Re: Docket No. 40-8903
License No. SAU-1471
Up-date of Table 2 - Groundwater Monitoring Program (8-97)
Revised Figures 7, 15, 16, 17, 22, 23, 24, and 31

HOMESTAKE MINING COMPANY

Re: DP-200
Up-date of Table 2 - Groundwater Monitoring Program (8-97)
Revised Figures 7, 15, 16, 17, 22, 23, 24, and 31

Figure 7
Well 0434

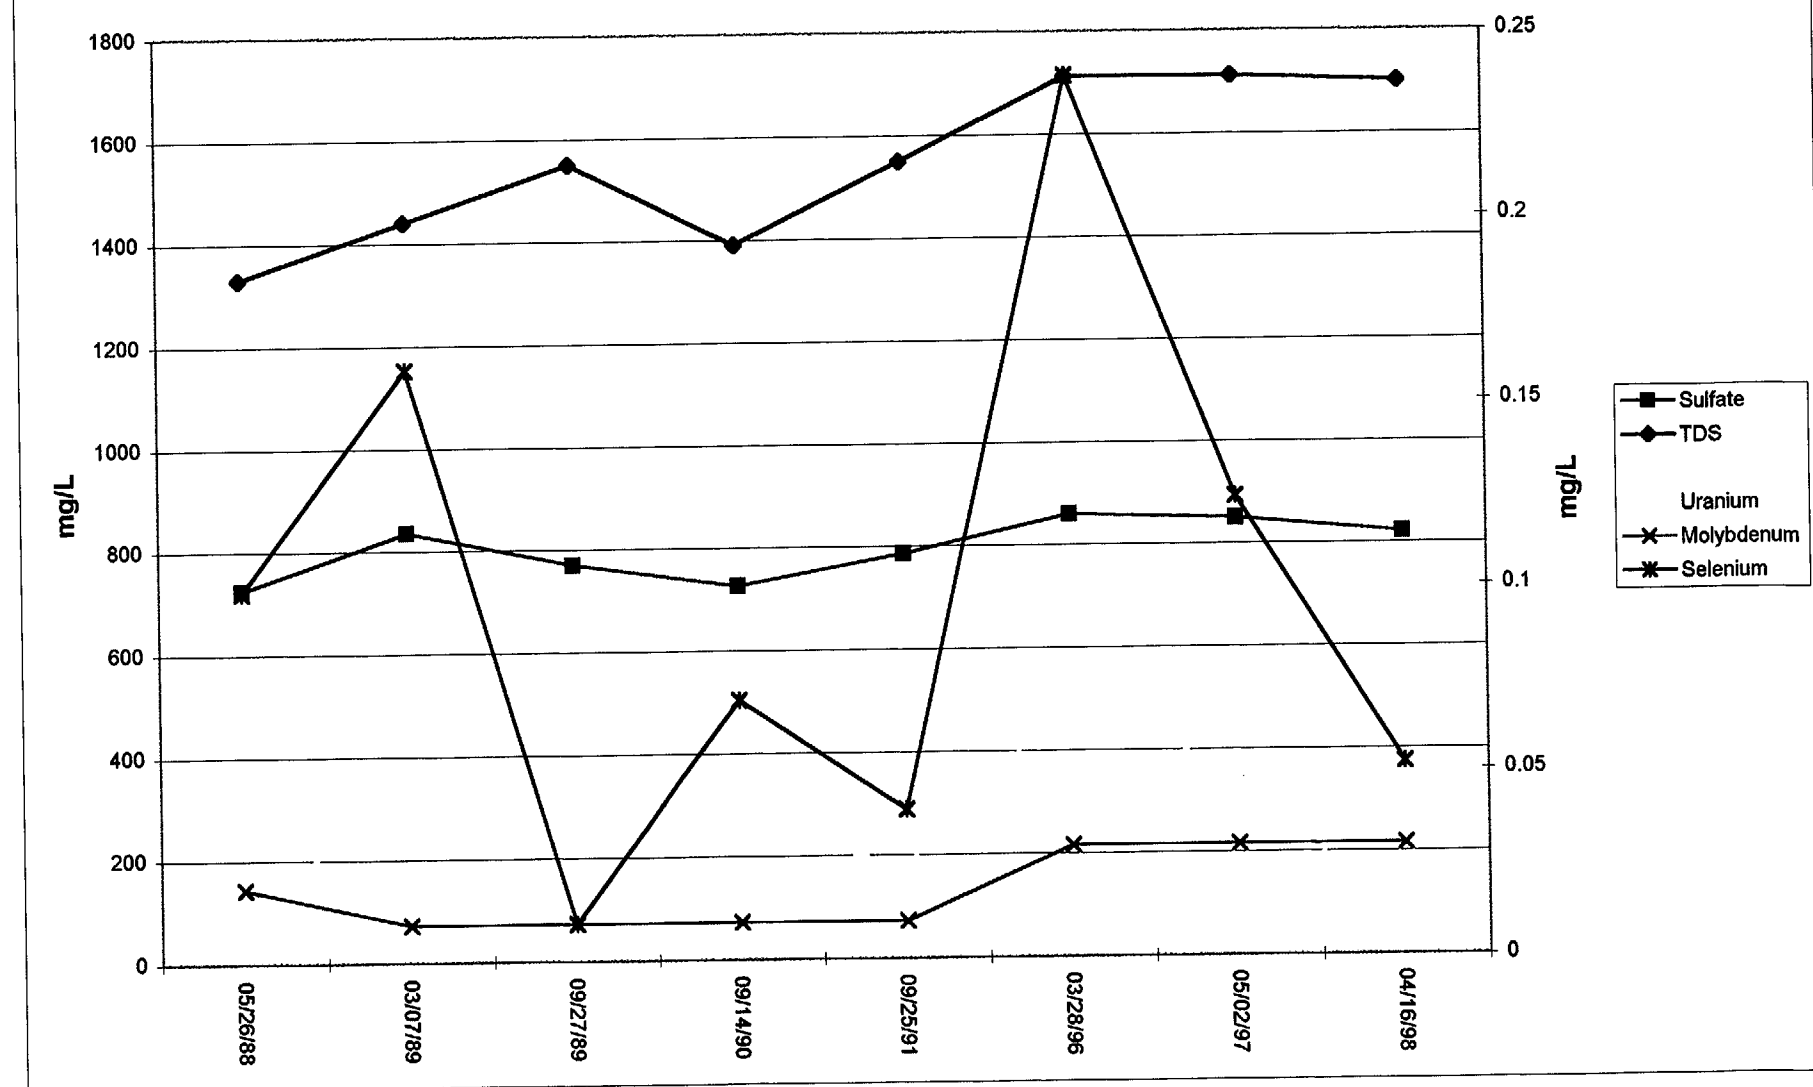
Enclosed are two copies of revised trend analysis figures to replace the above referenced figures that were submitted with the September 29, 1999 proposal to up-date Table 2. The previously submitted figures were graphs created from excel files that had not been ordered chronologically. The dates corresponded to the correct concentration data but were not sorted chronologically along the X axis. The revised figures have been corrected to show concentration data chronologically along the X axis. The trends in the revised figures still show the same general decline of concentrations over time. The most recent concentrations illustrated by these figures are below NRC and State site standards. Therefore the monitoring wells associated with these figures are proposed to be eliminated from the Table 2 monitoring requirements.

It has come to our attention that some of the figures that were submitted with the September 23, 1999 supplement to our proposal to up-date Table 2 had data that was not ordered chronologically along the X axis. Enclosed are copies of revised trend analysis figures to replace the above referenced figures. The previously submitted figures were graphs created from excel files that had not been ordered chronologically. The dates corresponded to the correct concentration data but were not sorted chronologically along the X axis. The revised figures have been corrected to show concentration data chronologically along the X axis. The trends in the revised figures still show the same general decline of concentrations over time. The most recent concentrations illustrated by these figures are below NRC and State site standards. Therefore the monitoring wells associated with these figures are proposed to be eliminated from the Table 2 monitoring requirements.
